BUILDING CODE OF AUSTRALIA COMPLIANCE ASSESSMENT REPORT

CHILDCARE CENTRE

Lots 1 & 2, DP1230557, No. 2-6 Chalker Street, THIRLMERE

REPORT NO. ► PROJECT #9212 - REV #01

D3.2 Access to buildings

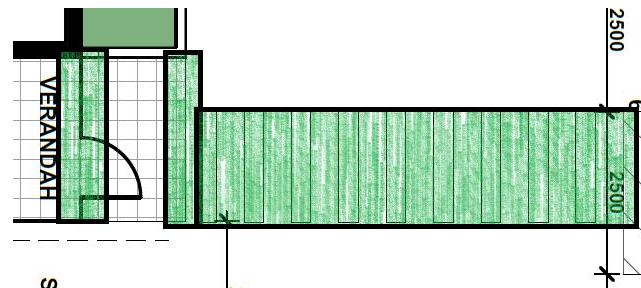
An accessway must be provided to a building required to be accessible from the main points of a pedestrian entry at the allotment boundary.

Access way to the building details different floor surfaces. The abutment of surfaces shall have a smooth transition. In the event the difference in level is more than 0 ±3 mm a threshold ramp is required to be provided in accordance with Clause 10.5 of AS1428.1 – 2009

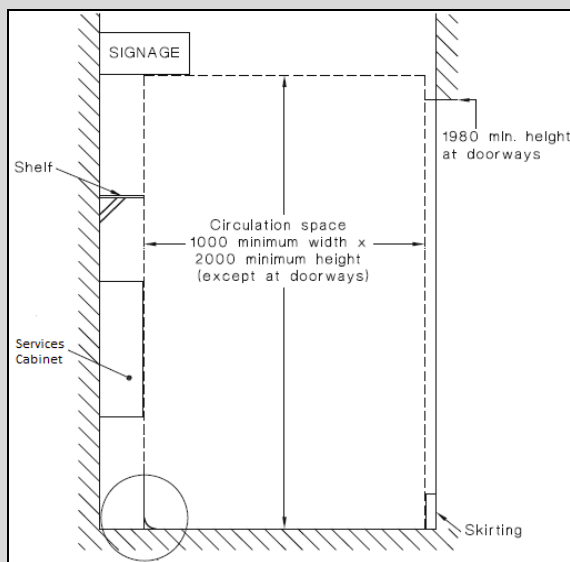
BCA DEEMED-TO-SATISFY PROVISION	COMPLIES	DOES NOT COMPLY	NA or Informational	Compliance Required	COMMENTS																				
<p><u>D3.1 - General building access requirements</u></p> <p>Buildings and parts of buildings must be accessible as required by Table D3.1, as follows:</p> <p><u>Class 9b Building</u></p> <p>To and within all areas normally used by the occupants (unless exempt by D3.4)</p>		X			<p>Office Door is to be provided with a 900mm latch side clearance</p> <div>

<p>(f) Latch-side approach, door opens towards user</p></div> <p>The Office, Staff Room, Common area, Laundry, Playroom's 1, 2 & 3 are to be provided with circulation space at the doorway.</p> <p><u>Slip-resistant floor surface/s</u></p> <p>BCA 2015 does not directly specify slip-resistance classification(s) for all accessible paths of travel; however, we highlight the need under AS1428.1-2009 for all accessible paths of travel to have a slip-resistant surface. We recommend you should seek surface finish advice from an independent specialist slip safety consultant.</p> <p>Spatial allowance in the current design indicates that compliance with AS1428.1-2009 is readily achievable.</p> <p>The following summary of AS1428.1-2009 requirements for accessways is provided to assist the project team.</p>	Dimension D	Dimension L	Dimension W _H	Dimension W _L	850	1670	110	900	900	1670	110	900	950	1670	110	900	1000	1670	110	900
Dimension D	Dimension L	Dimension W _H	Dimension W _L																						
850	1670	110	900																						
900	1670	110	900																						
950	1670	110	900																						
1000	1670	110	900

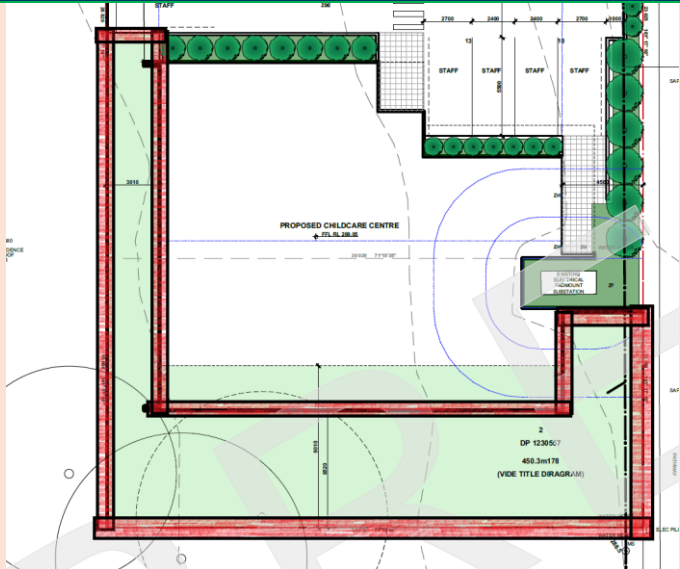
<p>1x Accessible sanitary facilities has been provided and is compliant for Class 3, 5, 6 and 9 employees.</p> <p>(a) Except where permitted by (b), (c), (f), F2.4(a) and F2.4(b), separate sanitary facilities for males and females must be provided for Class 9 buildings in accordance with Table F2.3.</p> <p>(b) If not more than 10 people are employed, a unisex facility may be provided instead of separate facilities for each sex.</p> <p>(c) If the majority of employees are of one sex, not more than 2 employees of the other sex may share toilet facilities if the facilities are separated by means of walls, partitions and doors to afford privacy.</p>
